Access Compliance Report

Public Rights-of-Way

(Curb Ramps)

Intersection ID: 13708	Main Street: WEST_BV	Cross Street: WICKFORD_PL	Location: SE
ADA ID: 3F9CE5472DDE	Ramp Type: Directional1	Initial Pass/Fail: Pass	Overall Compliance: No
Severity Score: 5.25			
Codes/Mitigation Info/Possible Solution		Field Measurements/Component Compliance

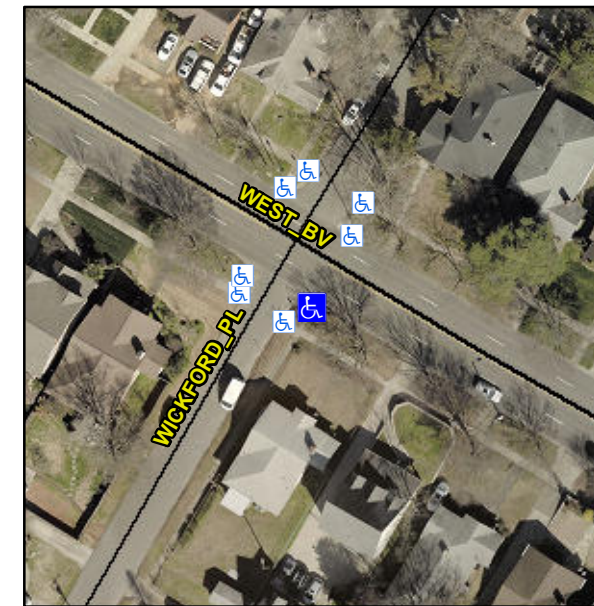
**Remove & Replace Entire Ramp.
Remove & Replace Gutter.**

R304.5.3, R304.2.1, R304.5.4
